Date of modification: 2020-04-24

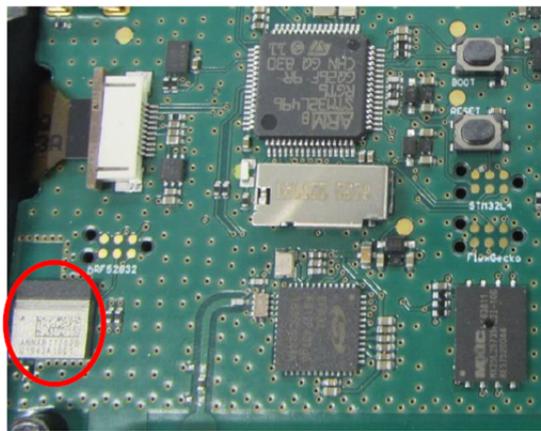
In order to improve the GPS reception  
Two ferrite bead capacitor filters has been added to the  
output off he CPU clock and MOSI line.  
In order to improve the spurious emission a via has been  
moved a litte farer from the TX line-

The bluetooth reference design has been adapted to the  
newest release.

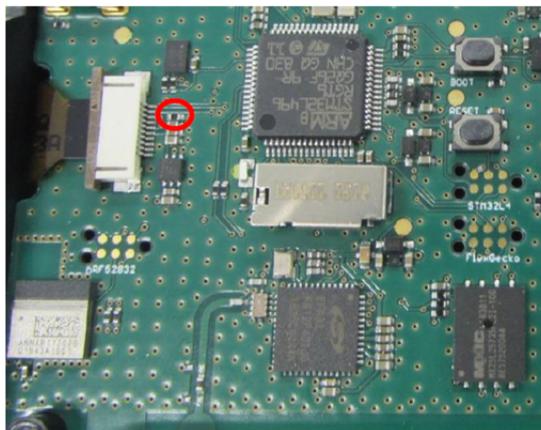
Pull Up resistor for LCD Display added. Connected  
Display\_Enable with MCU.
